ADDENDUM NO. 2

NIKE, INC.

NIKE RETAIL

LENOX SQUARE MALL - ATLANTA, GA

A2.01

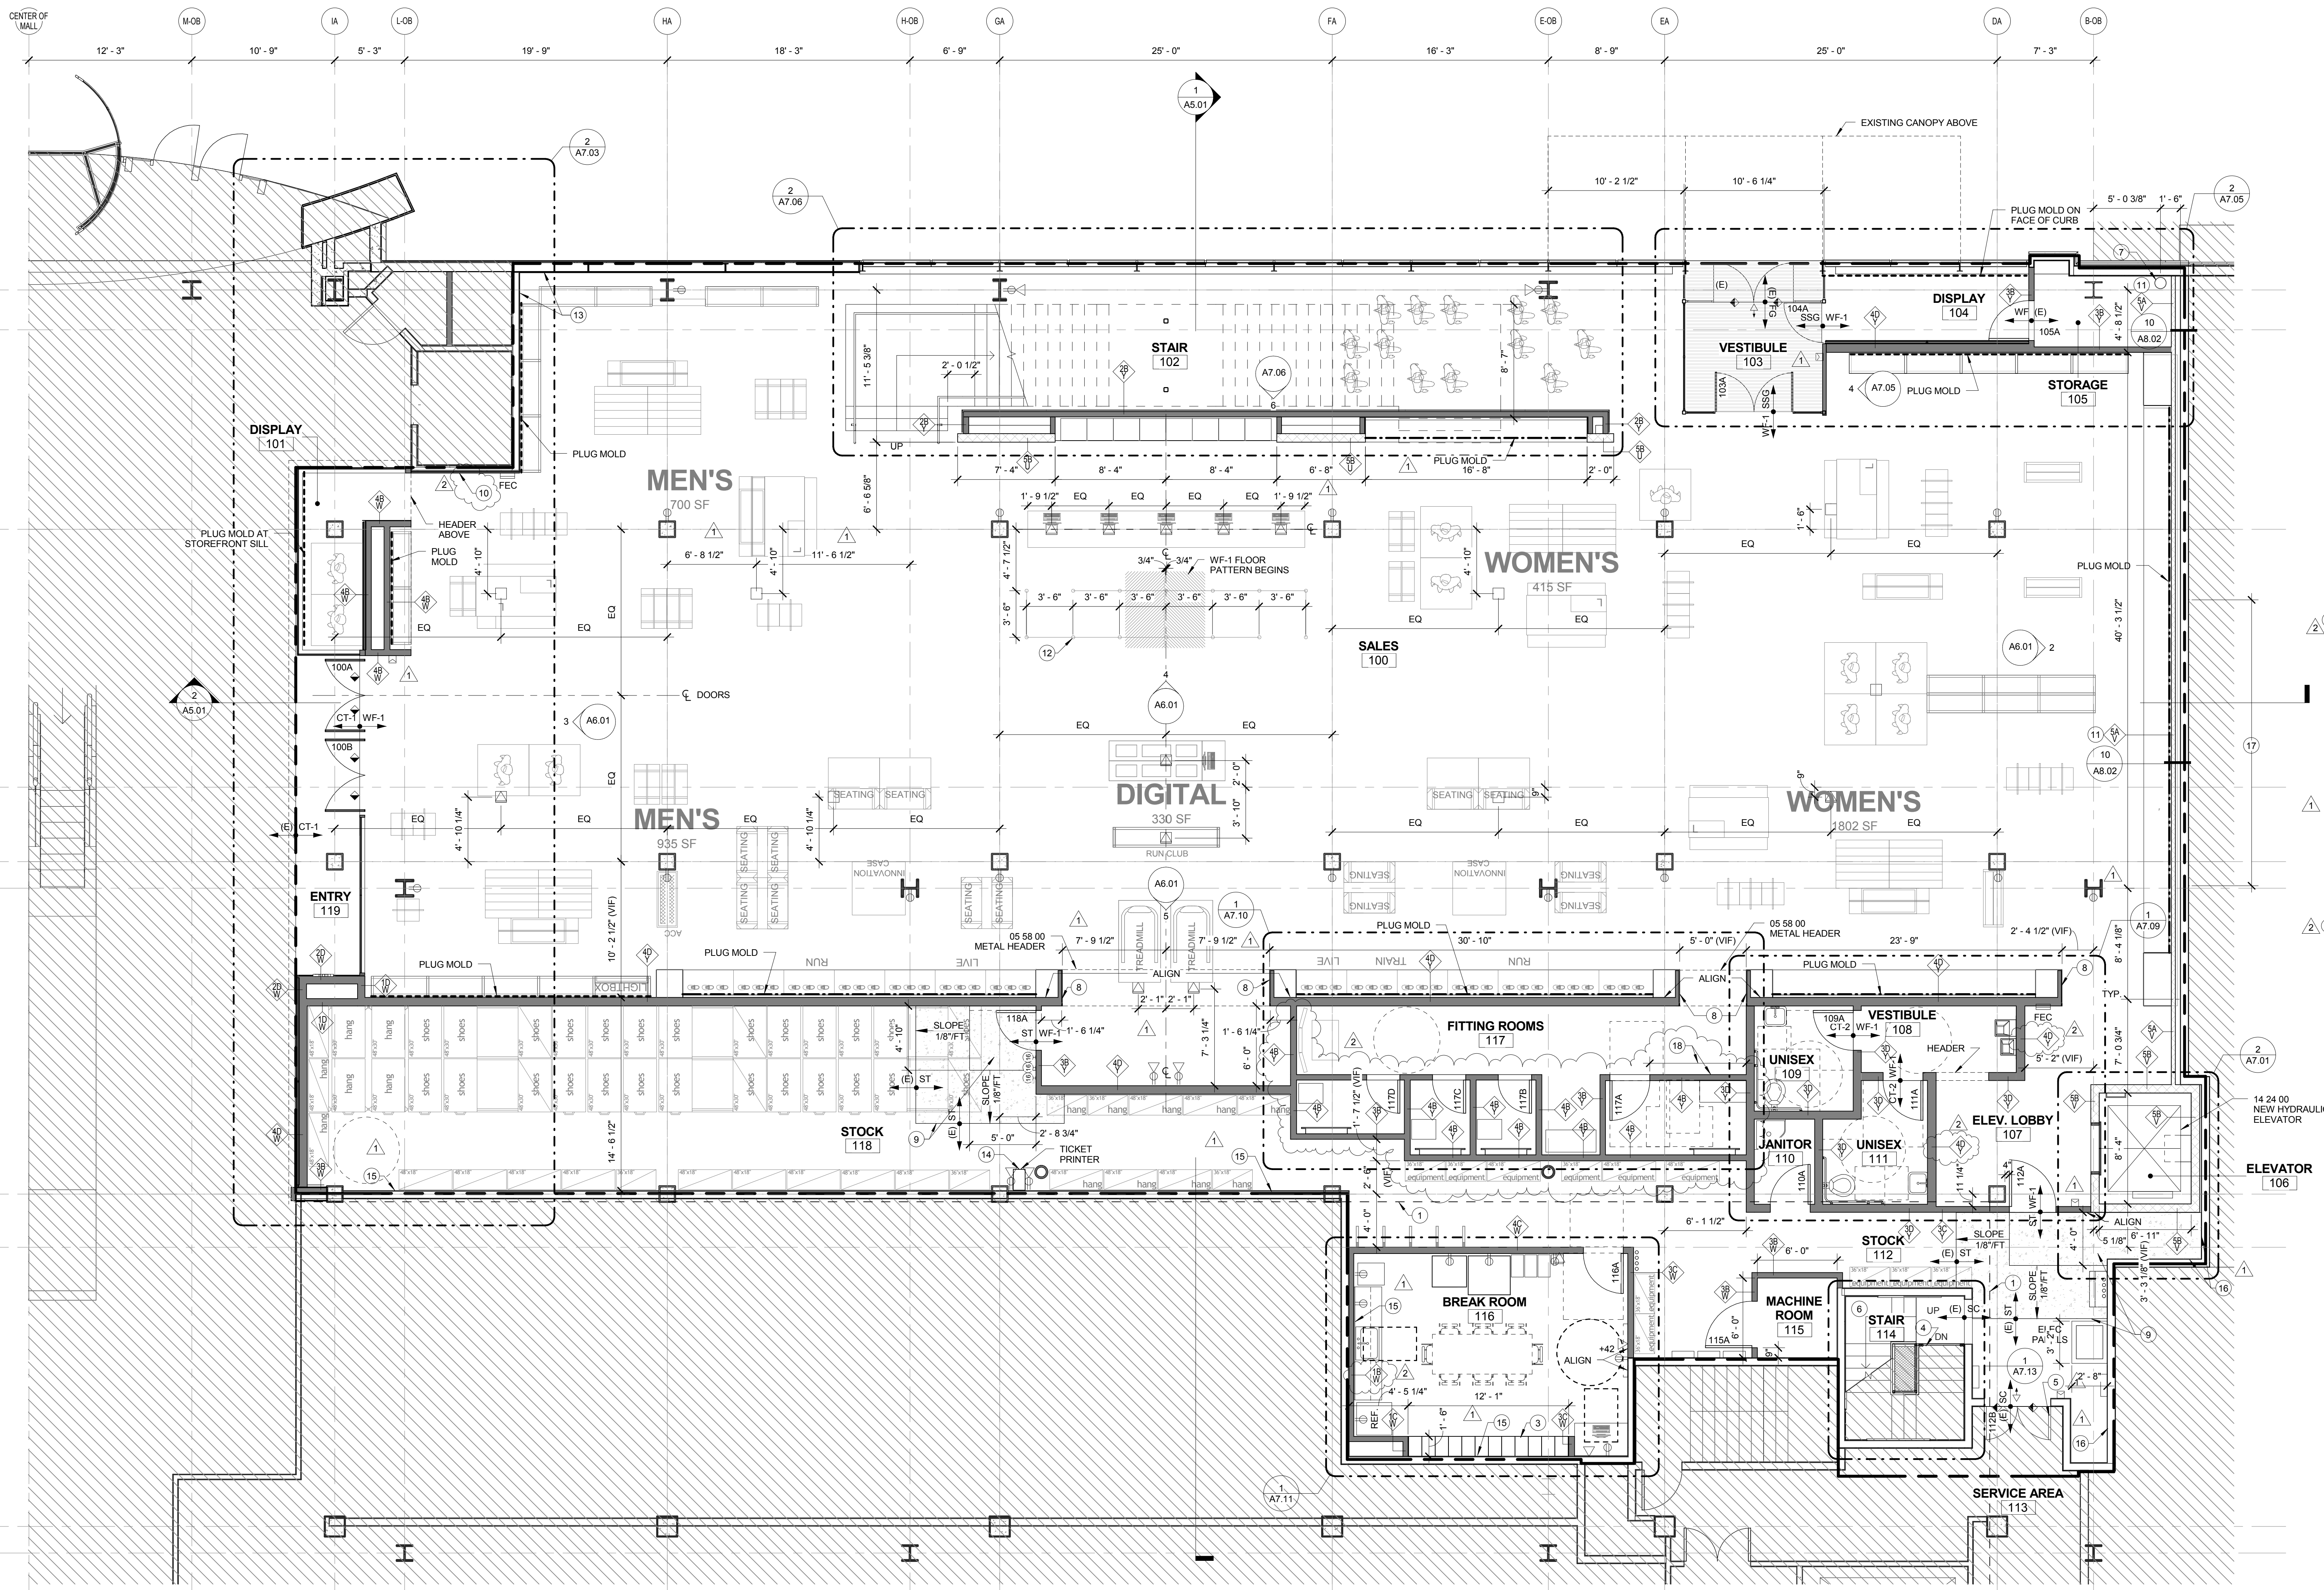
- 1.4 A2.01
Revise: Partition type at fitting room area and elevator lobby.
Revise: Sheet note 10
Add: Sheet note 18
Add: Furred out wall at west side of break room

A2.02

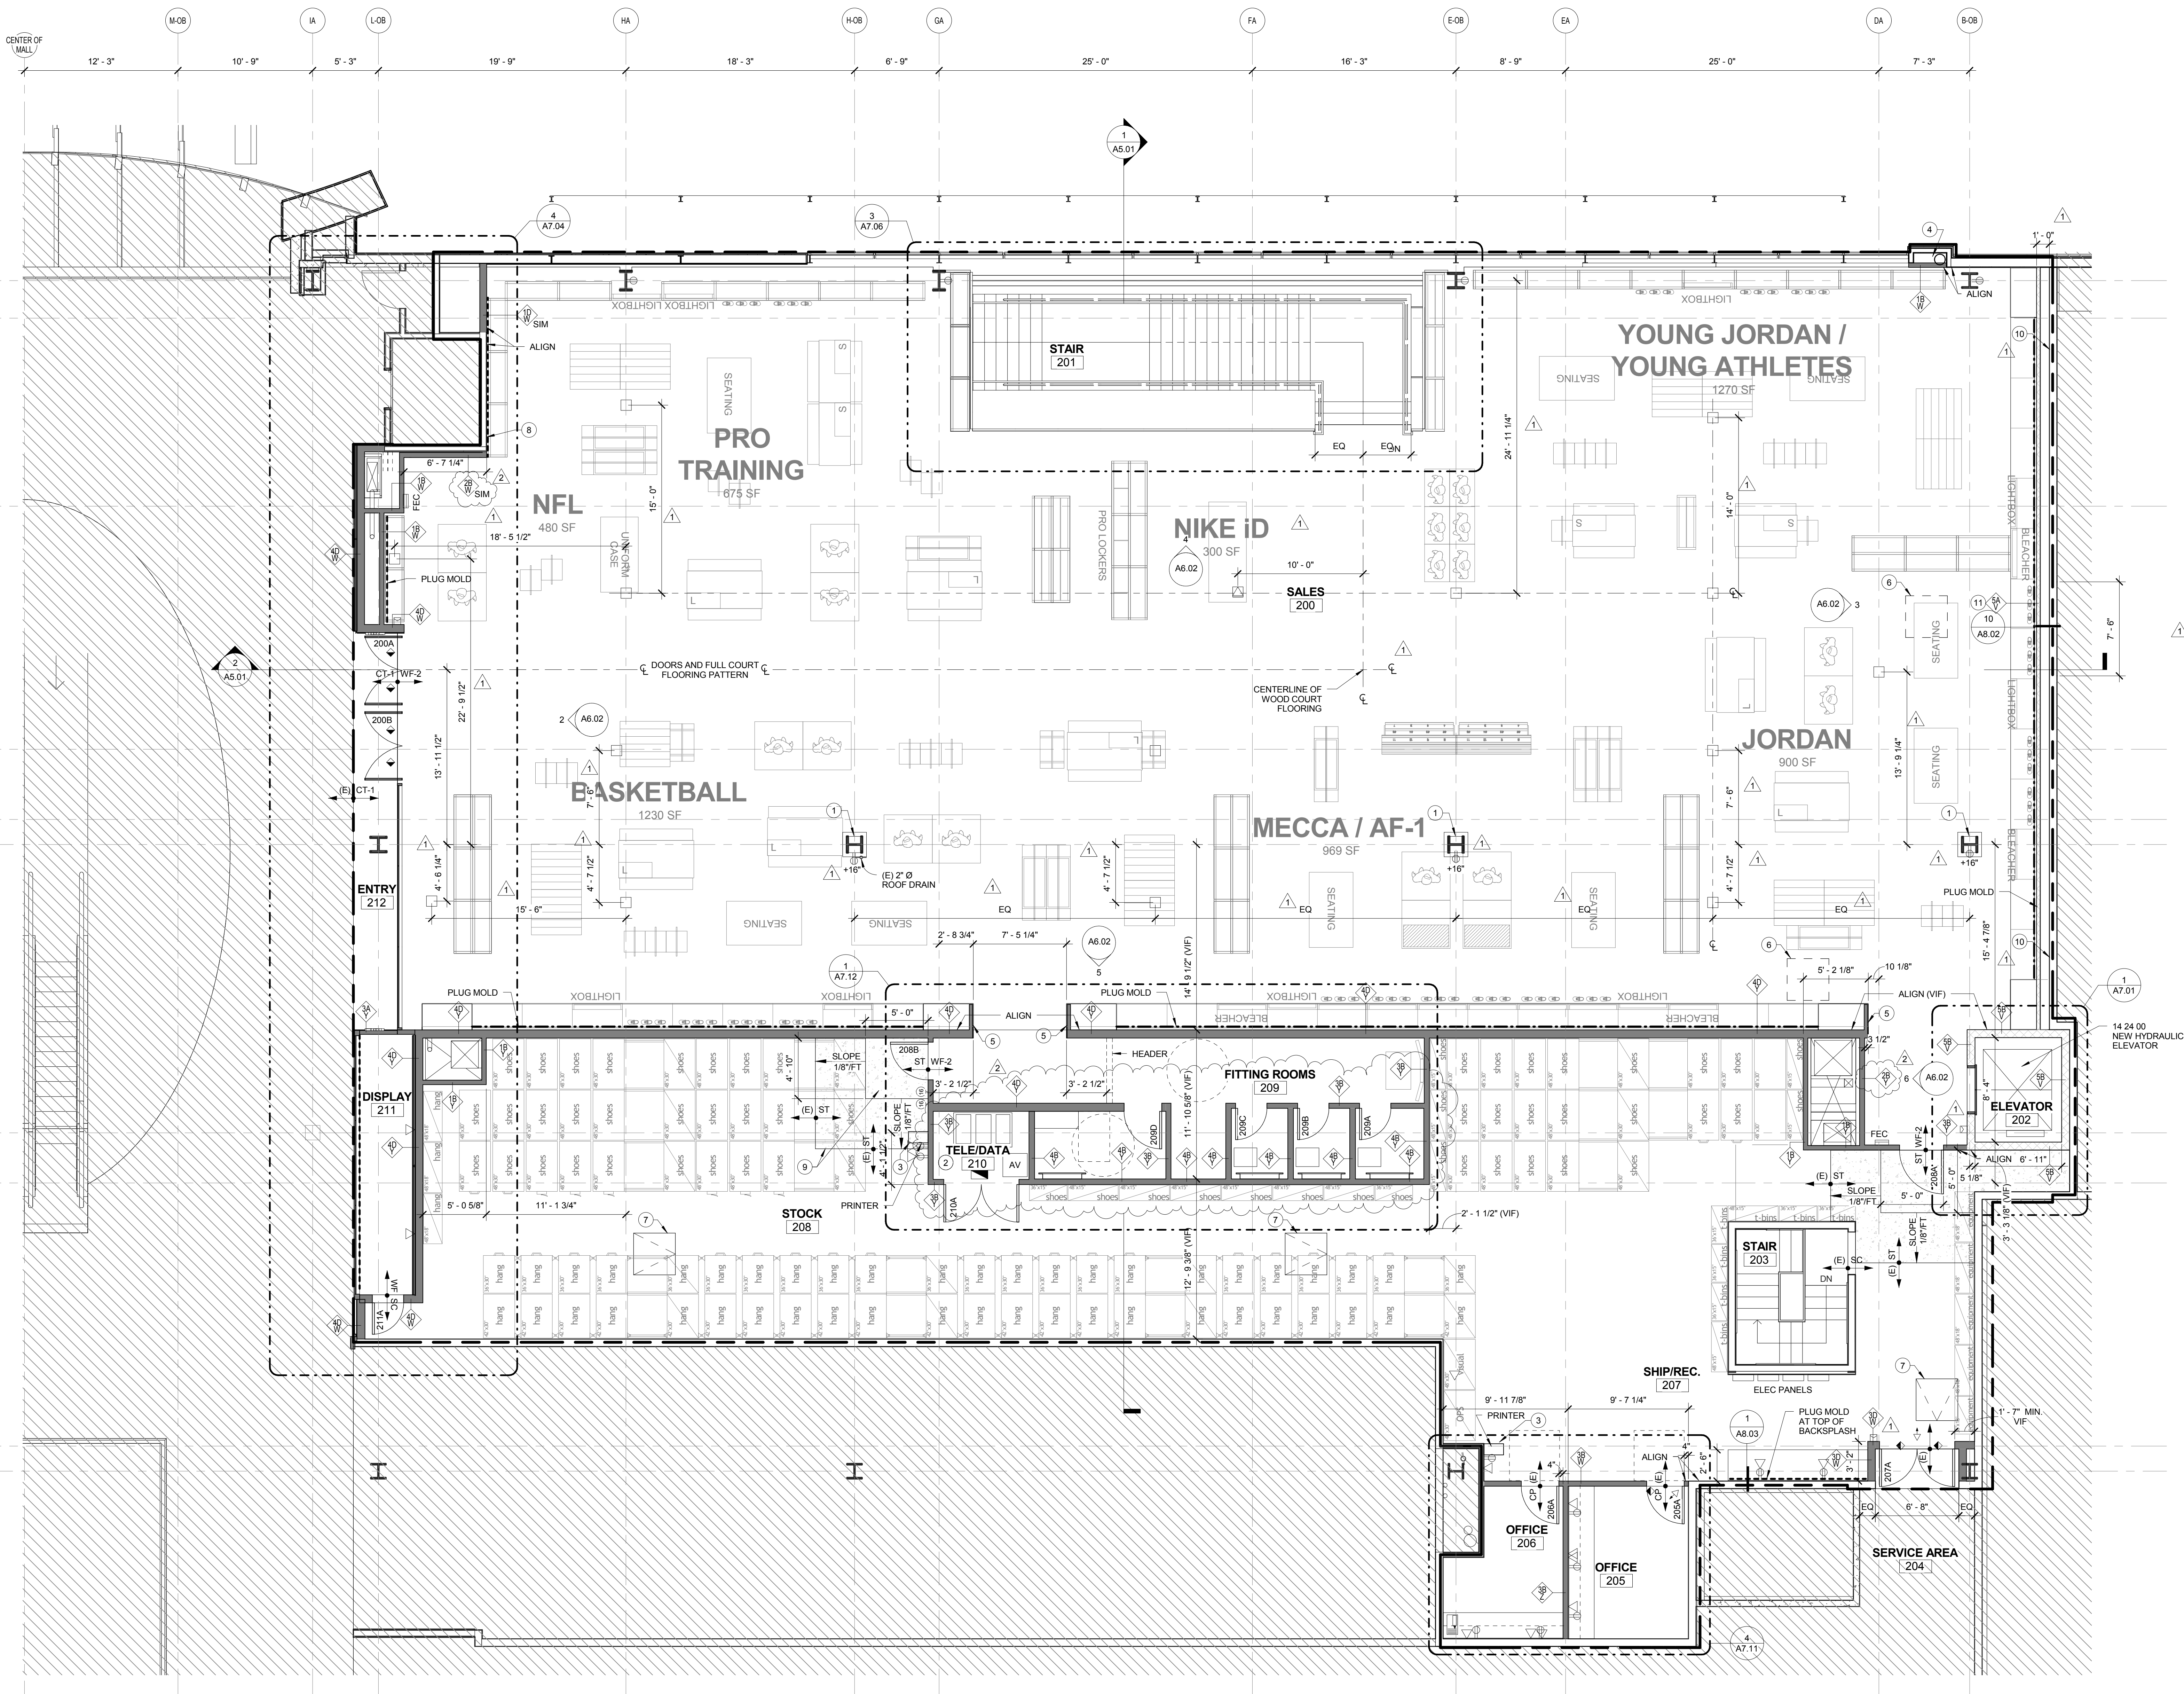
- 1.5 A2.02
Revise: Partition type at fitting room area, elevator lobby and at south side of mall elevator.
- 1.6 A3.02A:
Add: Detail 4/7/10/A8.06
- 1.7 A7.03:
Add: View #3 and 14 – door handles treatment
Revise: Height of 'Nike' push-thru signage

A7.04

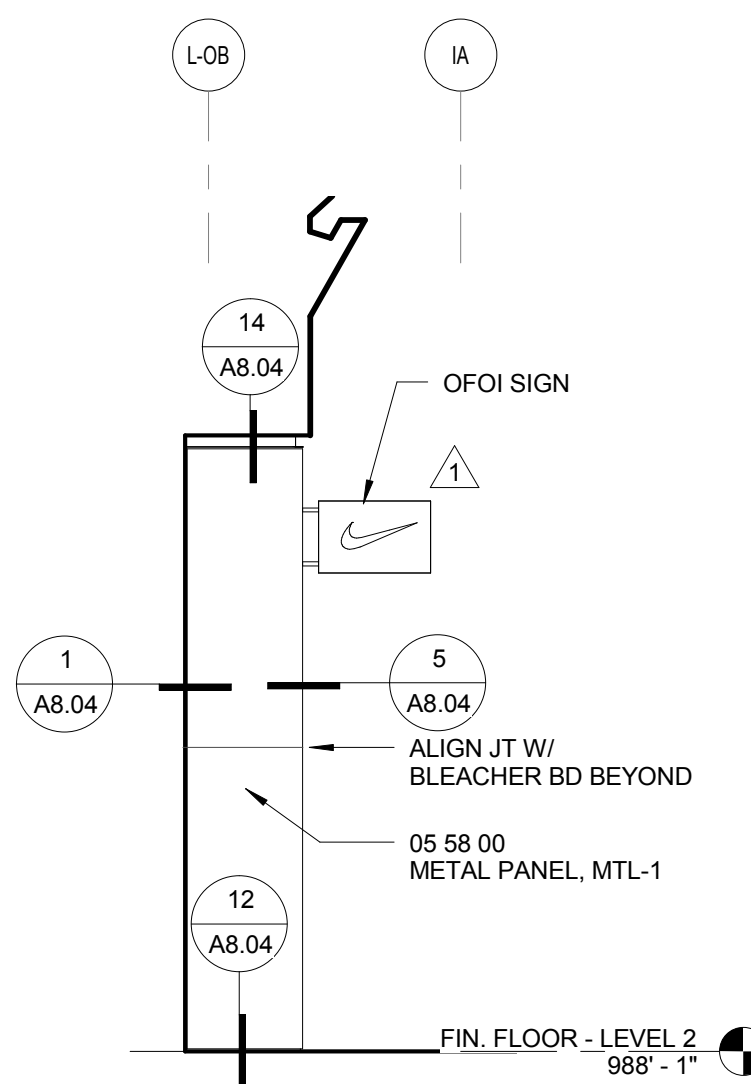
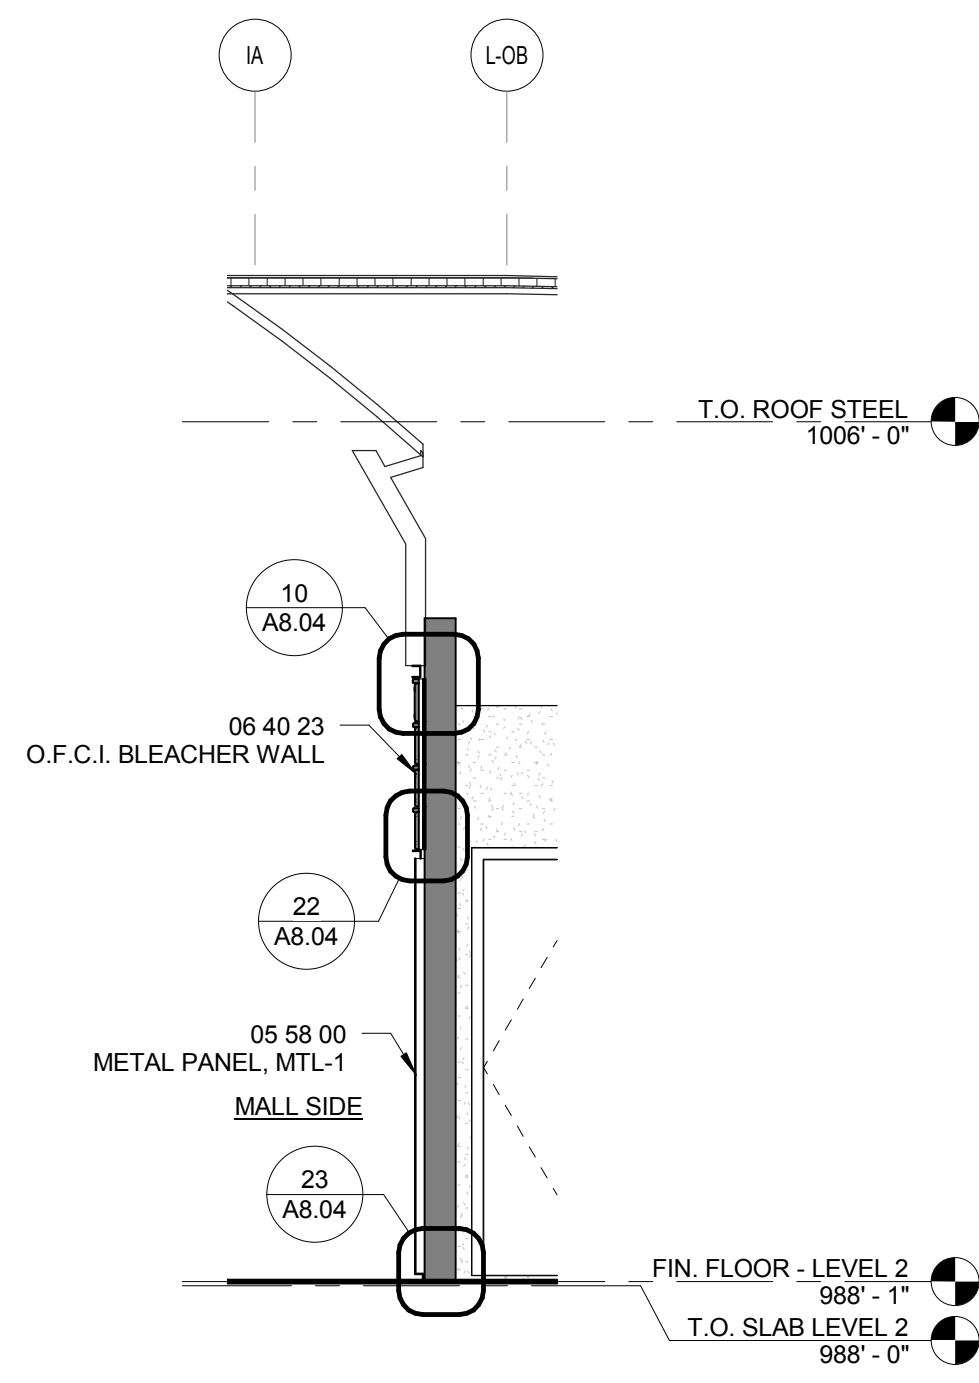
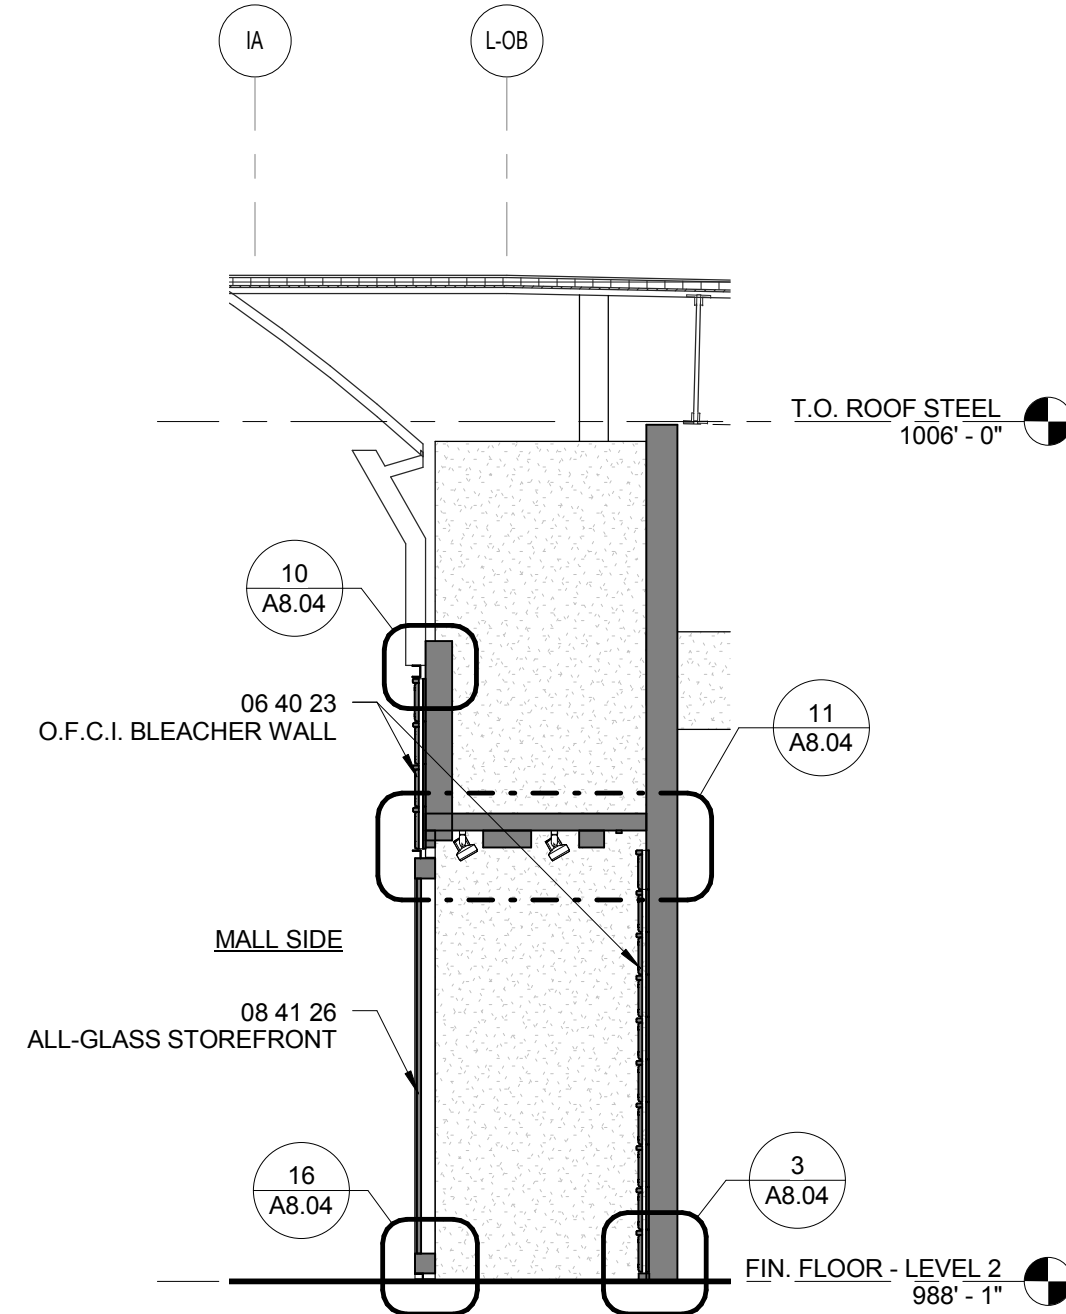
- 1.8 A7.04:
Add: View #1 and 8 – door handles treatment
Revise: Height of 'Nike' push-thru signage
- 1.9 A7.05:
Add: View #3 – door handles treatment
Revise: View #10 – linear bar grille size 6"X18"
